**STAFF REPORT
KETCHUM PLANNING AND ZONING COMMISSION
MEETING OF AUGUST 26, 2025**

PROJECT: Knob Hill Residence

APPLICATION TYPES: Mountain Overlay Design Review & Lot Consolidation Subdivision Preliminary Plat with Waiver Request

REQUEST: Mountain Overlay Design Review for the development of a new three-story, 6,212 gross-square-foot single-family residence and associated site improvements and Lot Consolidation Subdivision Preliminary Plat with Waiver Request to establish building envelope in 25% and greater slope

C1.0

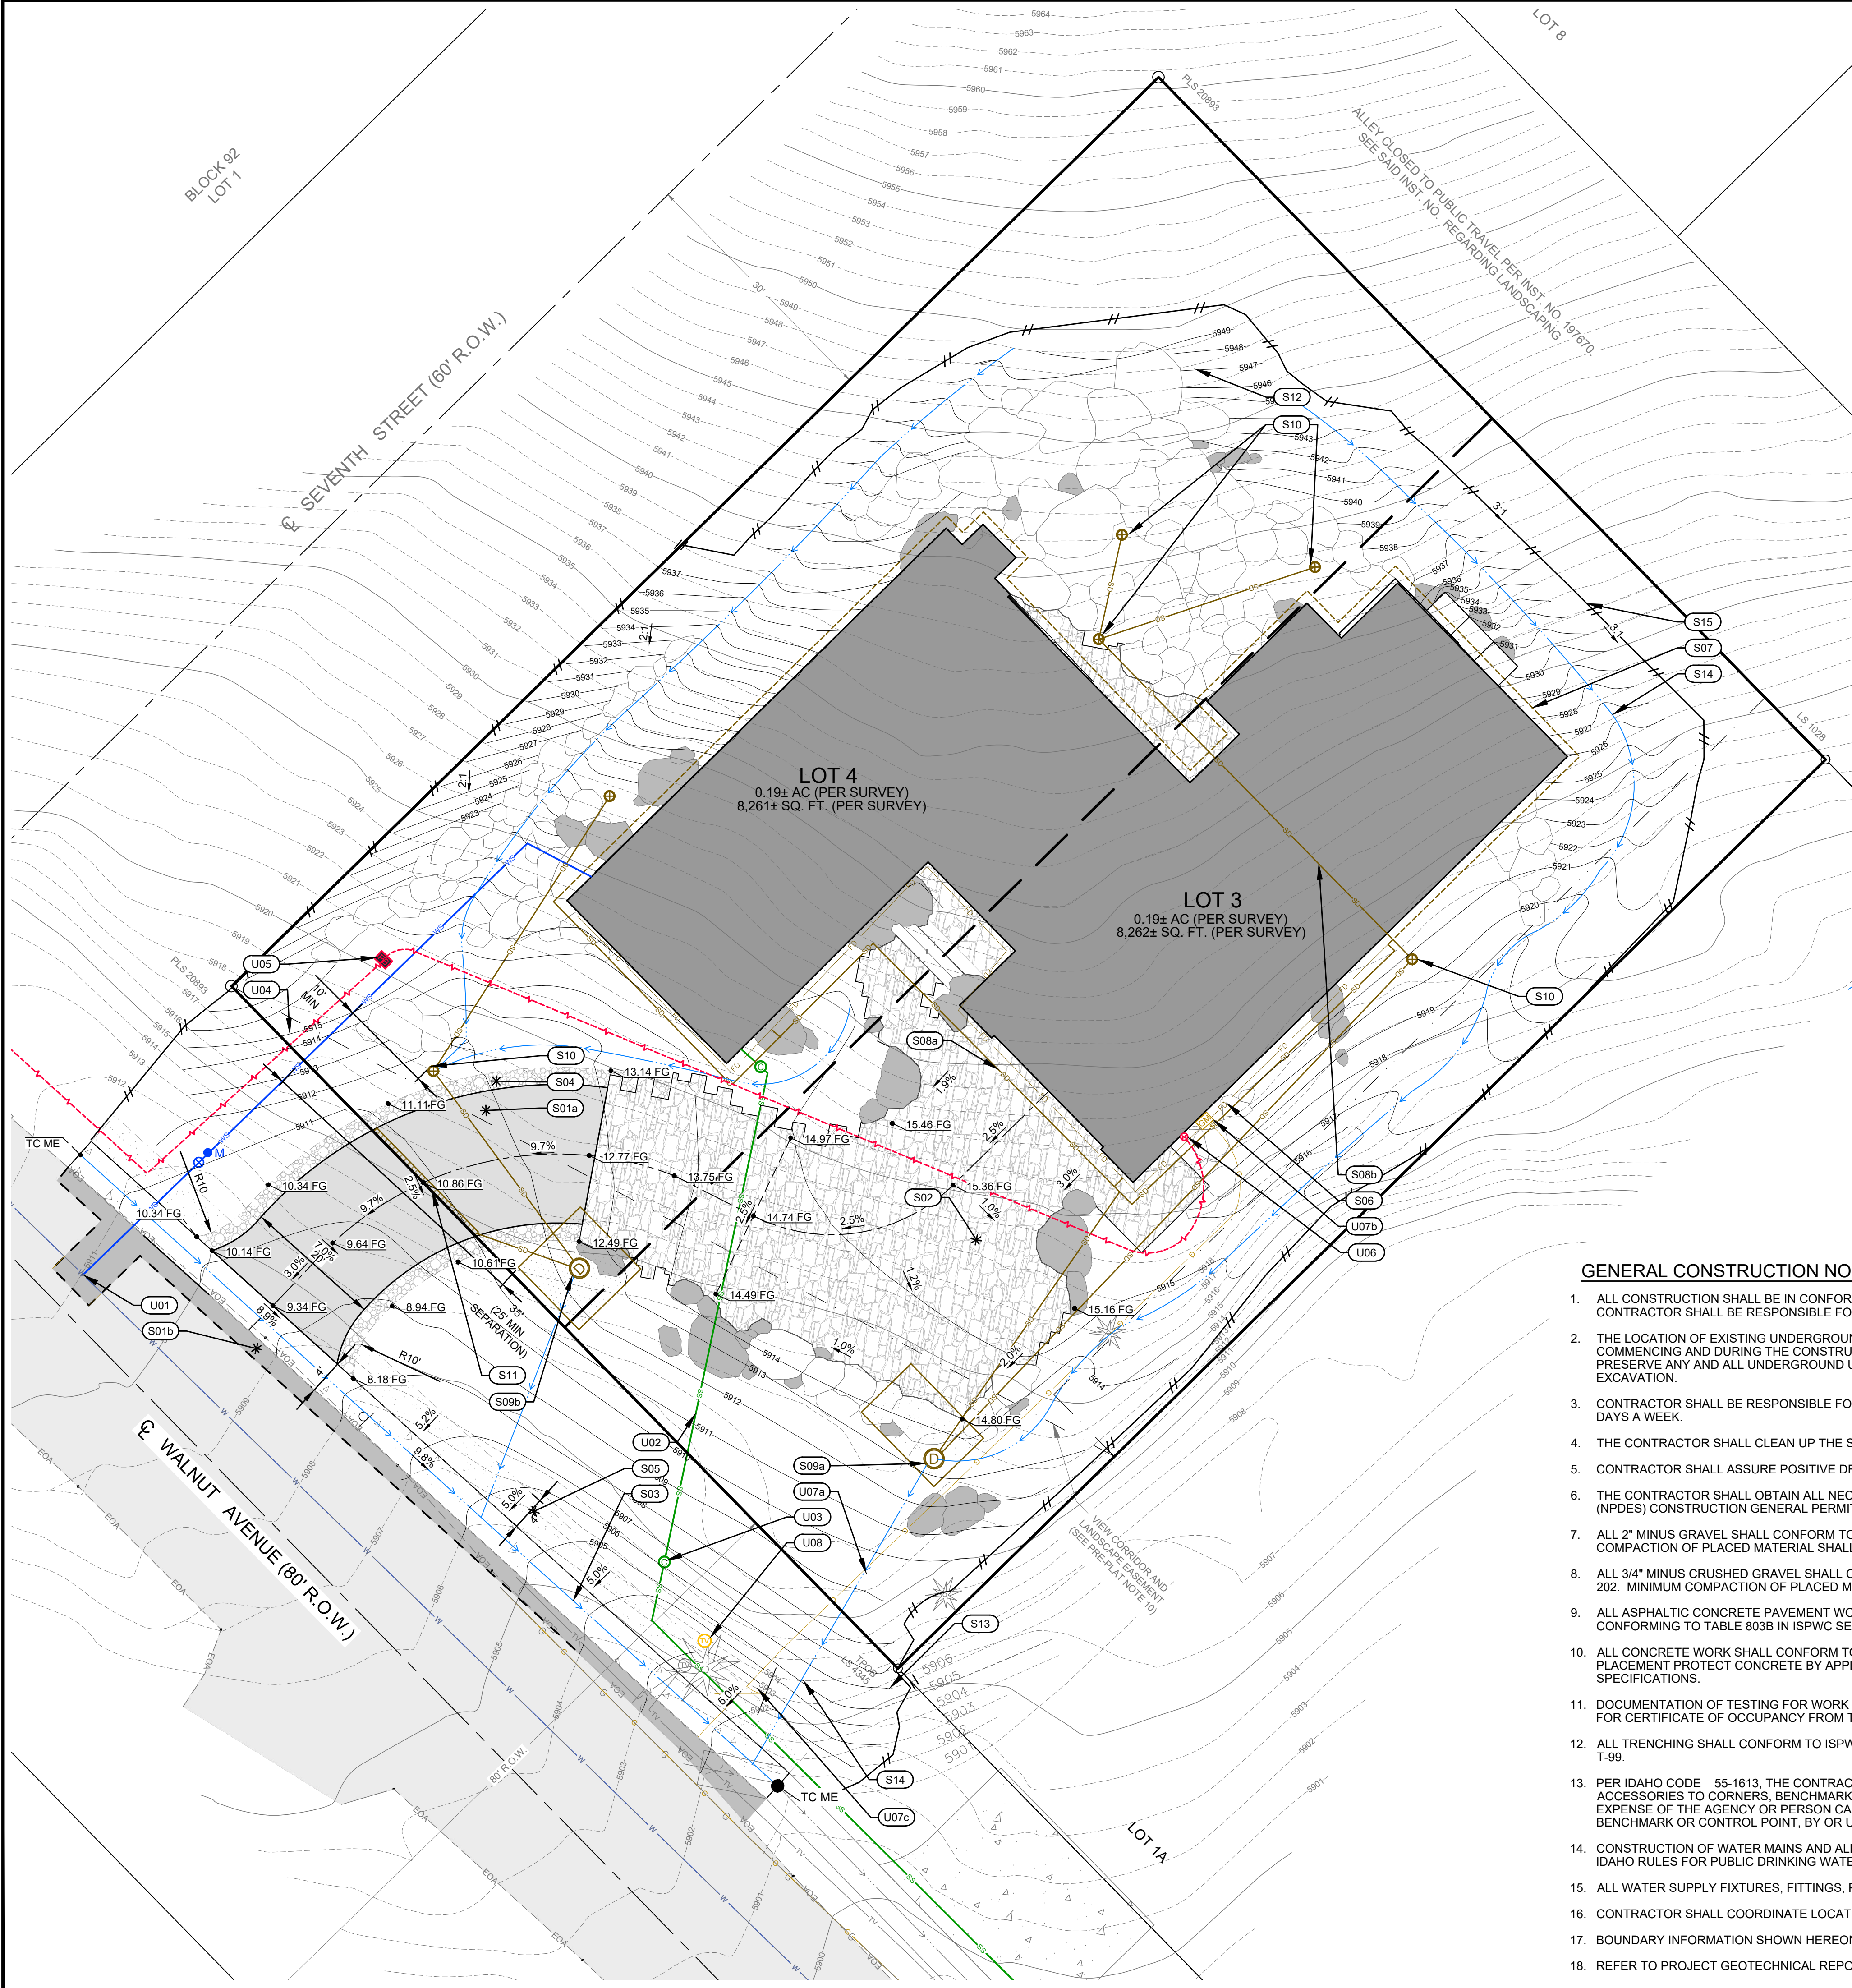
1. Comment: Transformer Screening—Pursuant to KMC §17.96.060.D2, “Utilities shall be located underground and utility, power, and communication lines within the development site shall be concealed from public view.” The Grading, Drainage, and Utility plan on sheet C1.0 shows that a new transformer is proposed to be installed in the front setback area at the northwest corner of the subject property. Note U05 states, “Proposed power transformer. Coordinate location with Idaho Power Co. Transformer to be screened with landscape on sides and rear. Maintain 10’ clearance in front of doors.” The project plans do not specify the

| | <p>infiltration rate is less than 0.1"/minute, then the drywells would need to be resized.</p> <p>Pursuant to KMC §17.96.060.C1, "All stormwater shall be retained on site." The geotechnical reports that "smaller landscape drywells may be slow draining and ineffective" due to the lower permeability of the bedrock and recommends all surface runoff be piped to a large drywell downslope of the structure. The grading and drainage improvements specified on sheet C1.0 of the project plans (see Attachment A) include a large drywell by the driveway adjacent to the front property line along Walnut Avenue. In case the on-site drywells overflow, the geotechnical report recommends drainage improvements be constructed in the public ROW along Walnut Avenue to capture any excess surface runoff.</p> <p>The proposed drainage improvements in the ROW along Walnut Avenue include the construction of a new concrete valley gutter that ties into the new storm drain system that was a required drainage improvement for the McDermott residence directly south of the subject property. The new storm drain system flows all the way to a drywell on 5th Street.</p> <p>KMC §17.96.060.C3 gives the City Engineer authority to require additional drainage improvements as necessary due to unique site characteristics. As the project proposes stormwater discharge into the ROW, the City Engineer requires that the applicant provide the following information at time of building permit:</p> <ol style="list-style-type: none"> 1. Infiltration tests at the bottom of drywell locations. 2. Calculations that include offsite drainage contributions, identify drainage basins, and demonstrate that post-development discharge to the ROW does not exceed pre-development discharge using 50% of the measured infiltration rates. 3. Verification that the drywell on 5th Street has the additional capacity for the post-development discharge. <p>The City Engineer flagged that modifications to the existing drywell on 5th Street or an additional drywell may be required. The City Engineer requirements have been added as recommended condition of approval no. 6 listed in section IV of the staff report.</p> | |

- c. Verification that the drywell on 5th Street has additional capacity for the post-development discharge. Modifications to the existing drywell on 5th Street or an additional drywell may be required.

C1.1

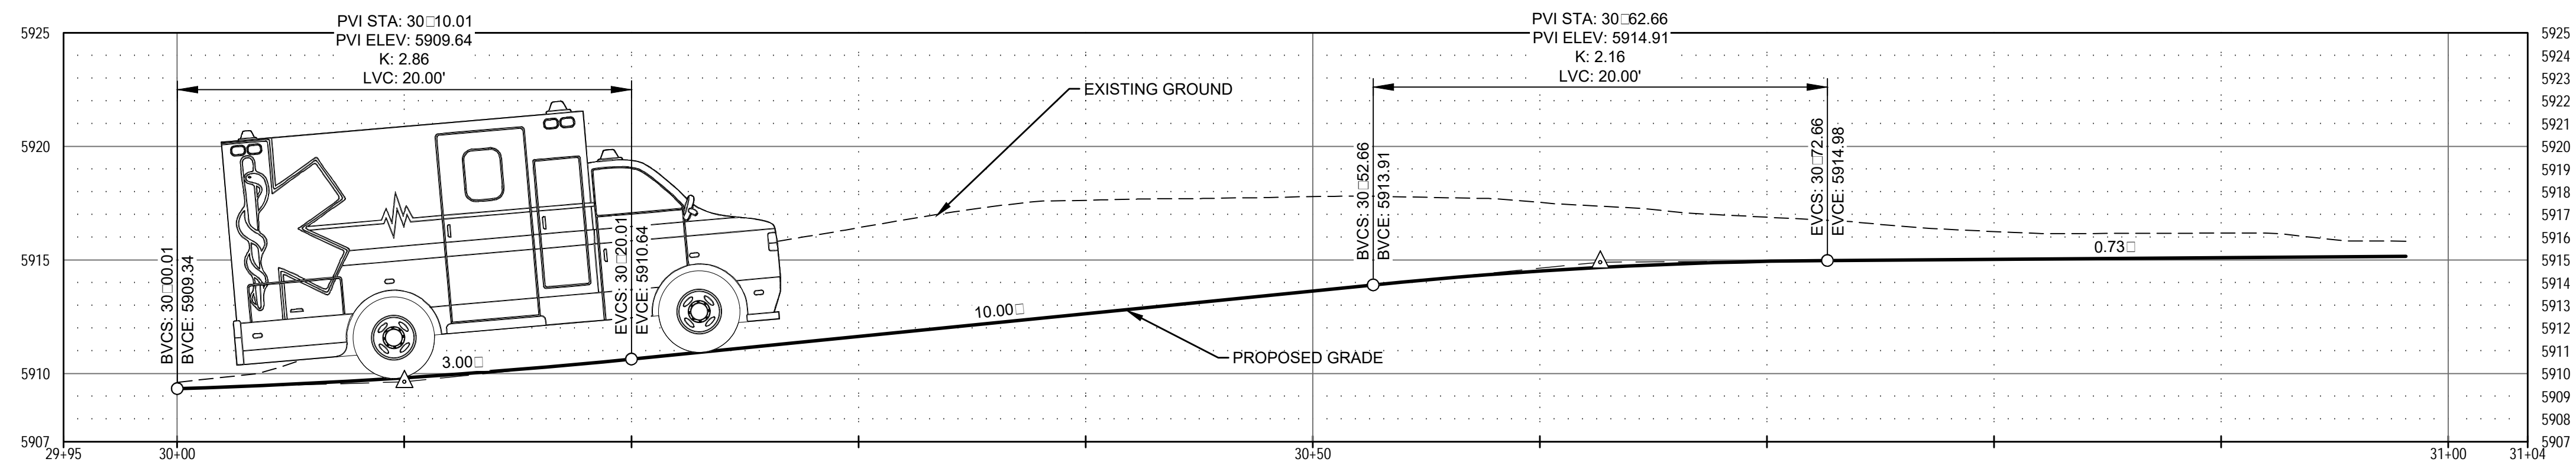
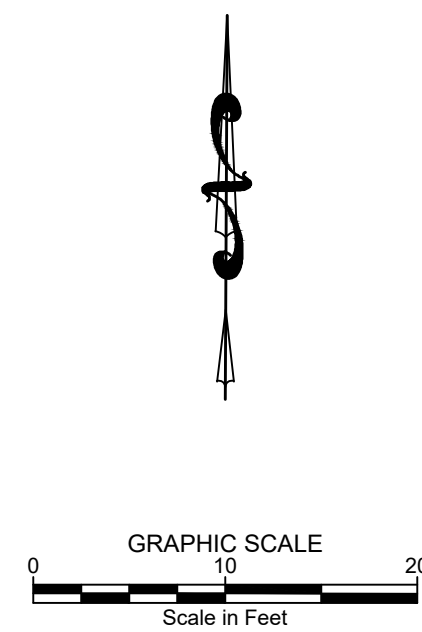
| Mountain Overlay Design Review Standards (KMC §17.107.070.A) | | |
|---|---|---|
| Staff Analysis | Please see staff analysis for KMC §17.104.070.A9 for an analysis of the proposed driveway length. The civil drawings on sheet C1.0 and C1.1 specify the proposed driveway improvements. The proposed driveway is 20 feet wide and a slope of 9.7%. The Fire Department requires snowmelt for driveways or portions of driveways with 7-10% slope. The entirety of the driveway is proposed to be snowmelted. The proposed driveway improvements have been reviewed by the City Engineer, Streets Department, and Fire Department and city department comments were transmitted to the applicant. At final MO Design Review, City departments conducted a code compliance review of the MO Design Review submittal and believe the project complies with all requirements. | |

Finding: The civil drawings on sheet C1.0 and C1.1 specify the proposed driveway improvements. The proposed driveway is 20 feet wide and a slope of 9.7%. The Fire Department requires snowmelt for driveways or portions of driveways with 7-10% slope. The entirety of the driveway is proposed to be snowmelted. The proposed driveway improvements have been reviewed by the City Engineer, Streets Department, and Fire Department and city department comments were transmitted to the applicant. City departments conducted a code compliance review of the MO Design Review submittal and believe the project complies with all requirements.
